PCN – Product Change Notification

PCN-A-1011217

PCN Topic: Winmate W32L300-CHA3 dimension changes

New Chassis Drawing: (with touch screen)

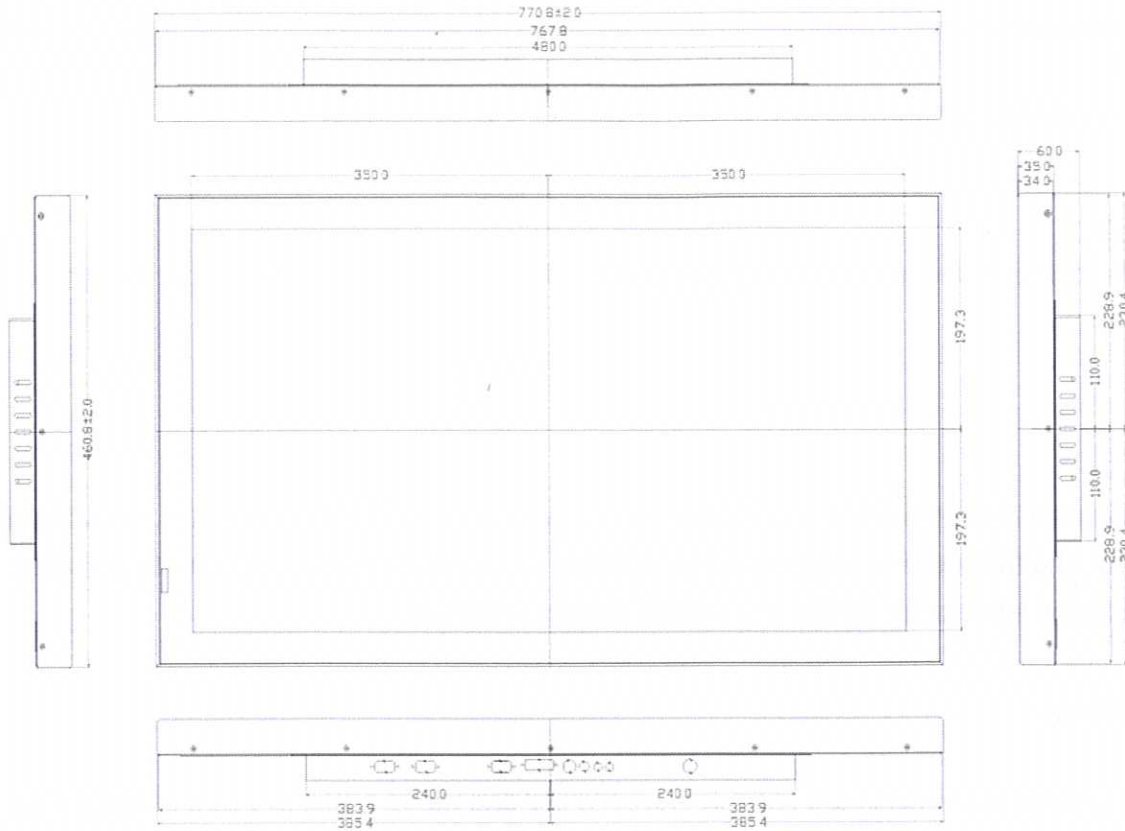
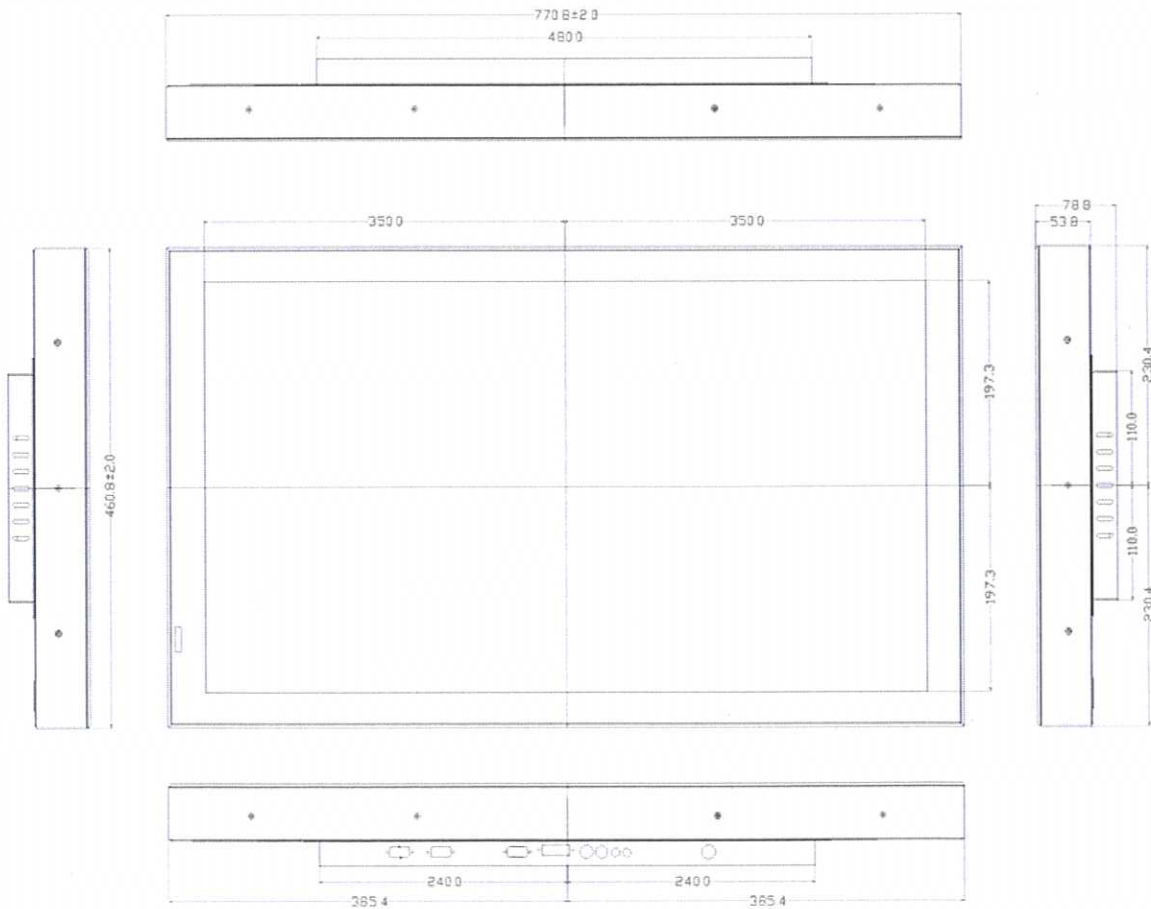
The dimension of **Chassis** housing will change from **770.8 X 460.8X 78.8 mm** to **770.8 X 460.8 X 65.0 mm**. (with touch screen) & to **770.8 X 460.8 X 60.0 mm** (without touch screen).
